# CITY OF SANTA BARBARA

## COUNCIL AGENDA REPORT

**SUBJECT:** Appeal Of Single Family Design Board Approval For 1117 Las Alturas Road Residence

**RE: SINGLE FAMILY DESIGN BOARD (SFDB) DECISION. MST2011-00142**

BUILDING FOOTPRINT COMPARISON

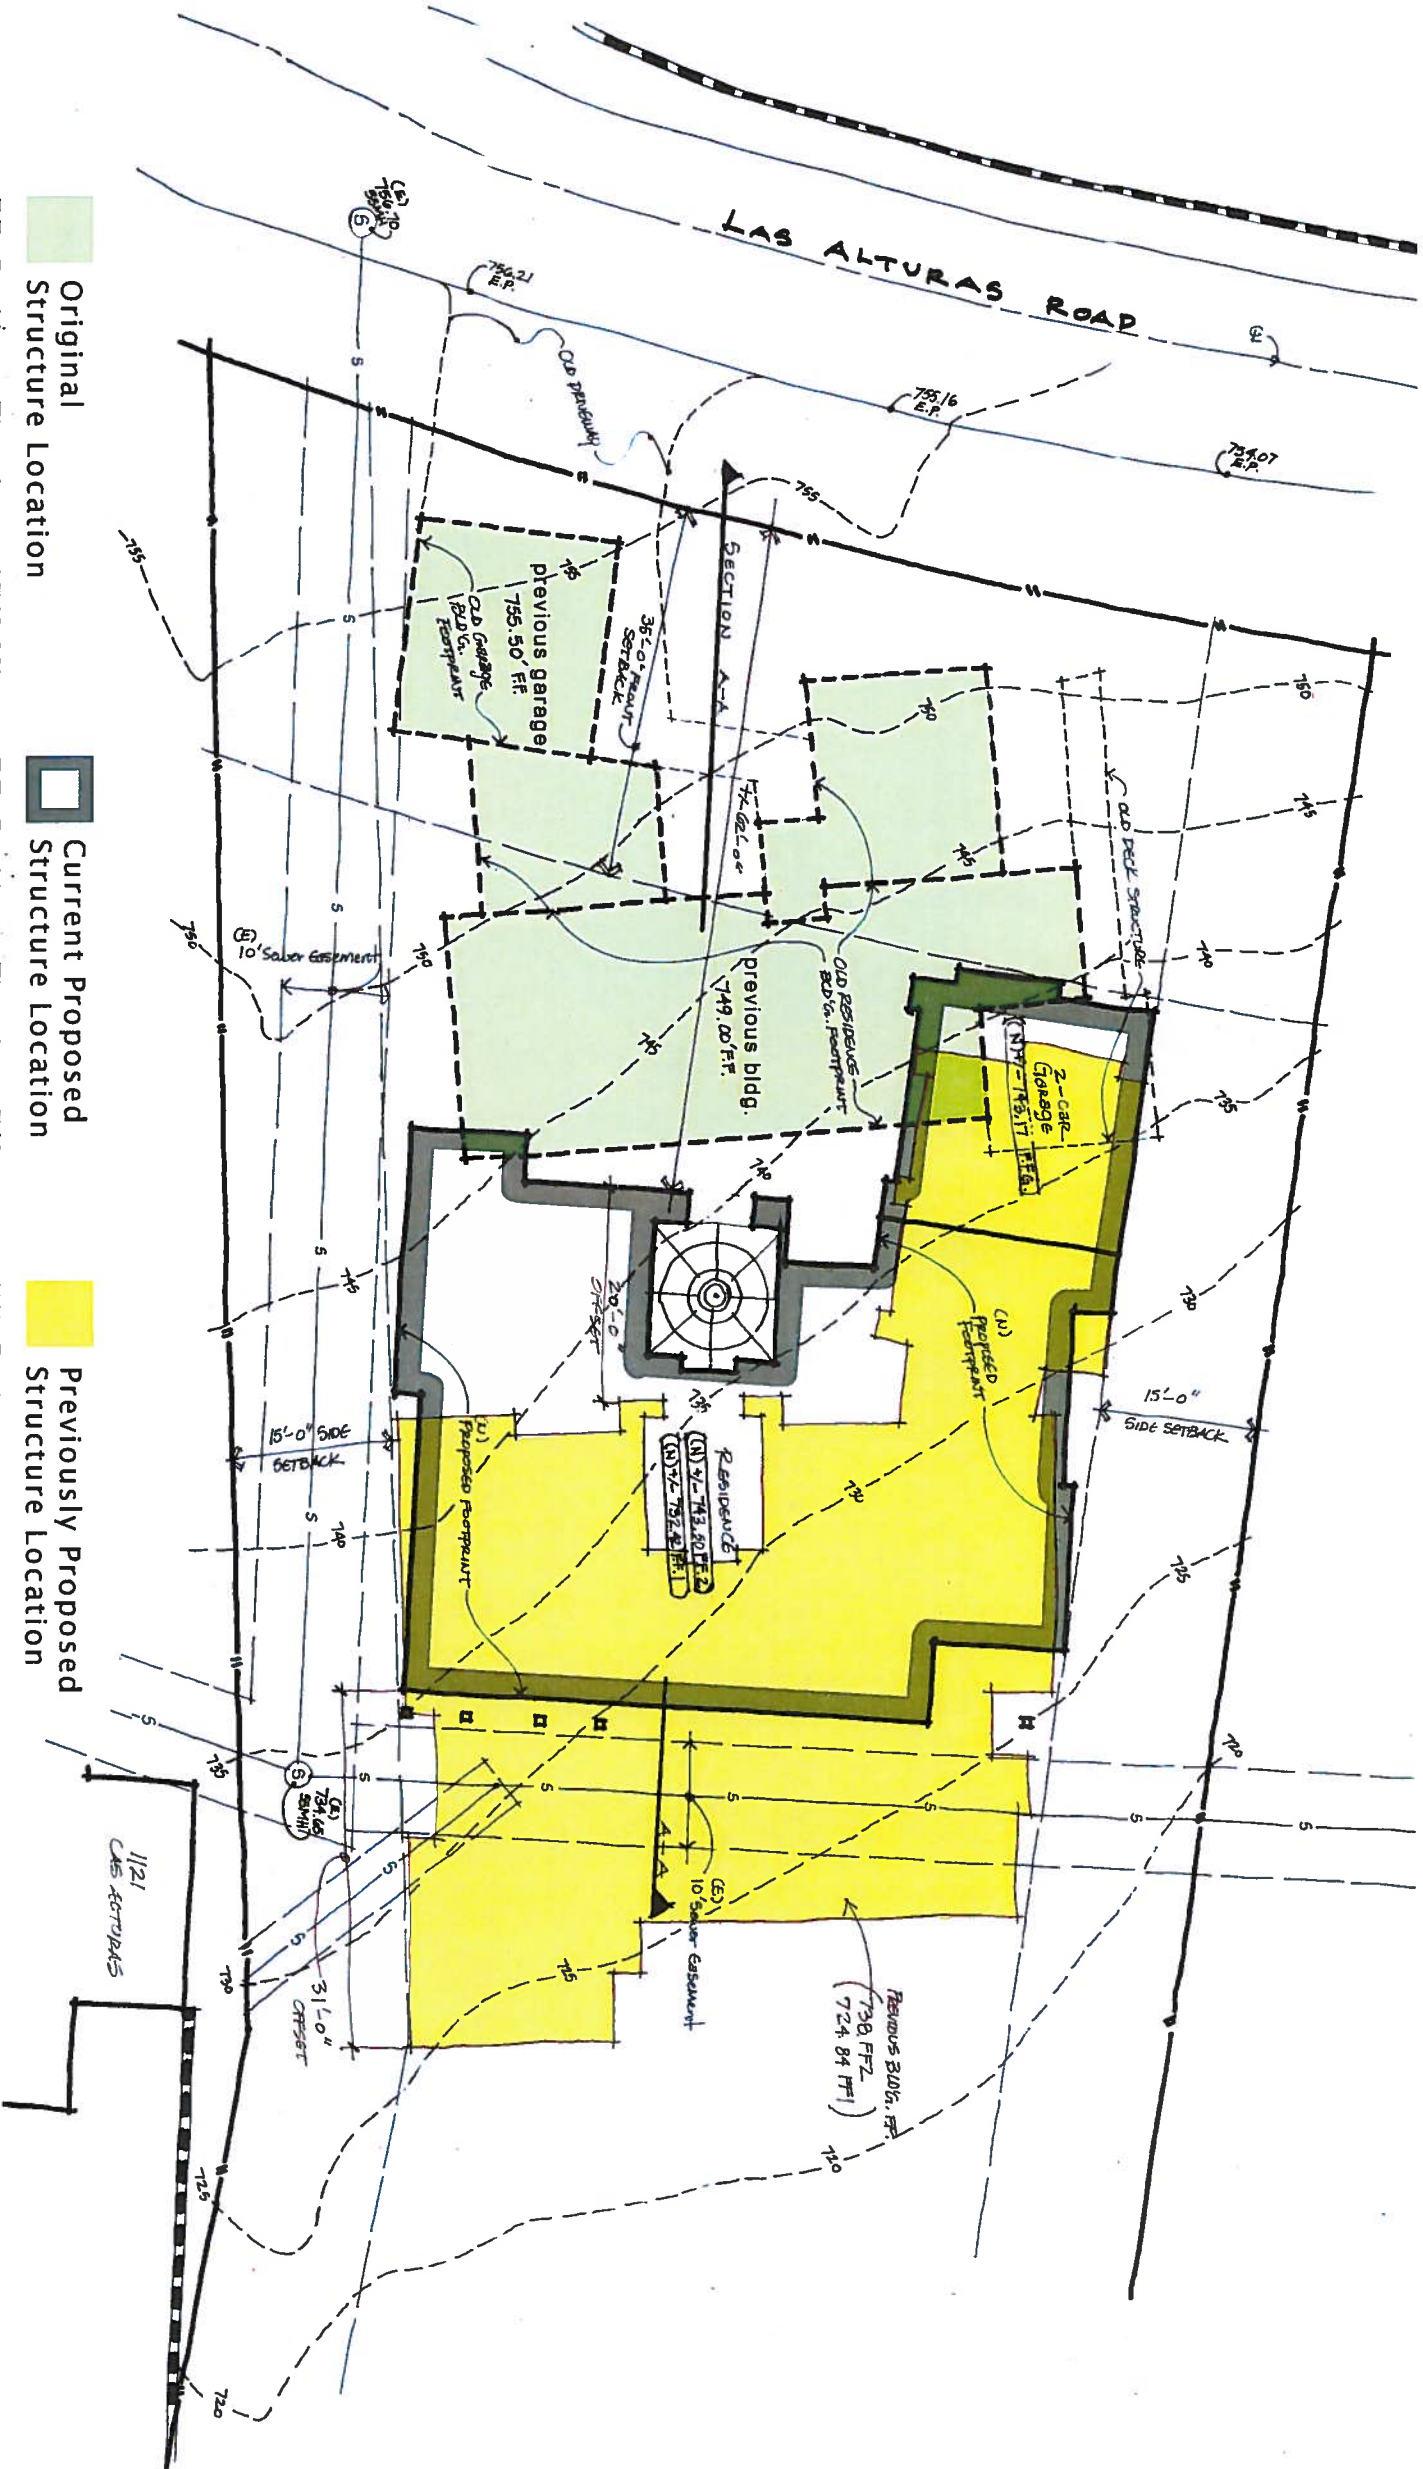
The previous residence was located in a different building footprint closer to Las Alturas Road and was destroyed in the Tea Fire in 2008 (see site plan, Attachment 2). The proposed design involves moving the residence location down the slope, a square footage increase, and requires site improvements to include a new driveway, site retaining walls, and approximately 1,255 cubic yards of total site grading. Grading includes 610 cubic yards of grading (210 cy cut/400 cy fill) underneath the building footprint and 645 cubic yards (345 cy cut/300 cy fill) of grading elsewhere on the site. A total of 743 square feet of decks are proposed, which includes 335 square feet of covered decks and 475 square feet of uncovered decks. The proposed total of 4,265 square feet, located on a 46,303 square foot lot in the Hillside Design District, is 85% of the maximum guideline floor-to-lot area ratio (FAR). After several meetings and reviews, the SFDB made the required Neighborhood Preservation Ordinance (NPO) Findings and granted Project Design Approval on September 12, 2011, by a unanimous 4/0/0 vote.

The appellant asserts that the proposed design presents privacy and view impact concerns regarding the location of the proposed home in close proximity to her home located next door to the east at 1121 Las Alturas Road. The appellant indicates the proposed two-story mass, which is 19 feet from her home, is too close and believes the house can be relocated up the hillside slope further away from her residence. Although the proposed residence at 1117 Las Alturas will comply with the minimum 15 foot setback distance, the closer proximity to the appellant's existing house next door results because

**Staff Position:** The SFDB full board reviewed various design proposals at five separate meetings. The first two meetings where the project was reviewed, the SFDB was concerned about the proposed building footprint location that required a City sewer line relocation and asked for the design to be altered to reduce building heights, avoid easements and to consider other design alternatives including moving the home up the hill. Considerable changes were made to the project design as a result of SFDB reviews including FAR reductions (refer to FAR table below). The current design is a good compromise that considers various concerns of all neighbors, including neighbors above this parcel. Staff believes the applicant has already made several design concessions to satisfy the SFDB comments and the various concerns raised by neighbors. Staff does not support additional design changes such as further home size footprint reductions or relocation of the home further away from the appellant's property up the hill that will necessitate zoning modifications for the project design.

Staff's position: Staff is of the opinion that the SFDB worked to reduce the height and scale of the residence and was successful in pushing the home location up the hill and away from existing sewer easement on the lower portion of the lot. The adjustment to the building footprint benefitted the appellant and improved some private views. In addition, story poles were erected in response to neighbor requests, roof forms lowered and the orientation of windows on the west elevation were adjusted to increase privacy between neighbors. These project changes demonstrate that reasonable consideration was given to the neighbors. Staff is concerned that the appellant believes that the appropriate solution to achieve an increased separation is to insist that applicant either reduce the home size or pursue zoning modifications. Staff supports the current house design that the SFDB approved given that it is consistent with zoning standards and is compatible in size with the recent tea fire rebuild project on the adjacent lot approved at 1105 Las Alturas Road and other homes in the neighborhood (see Attachment 5).
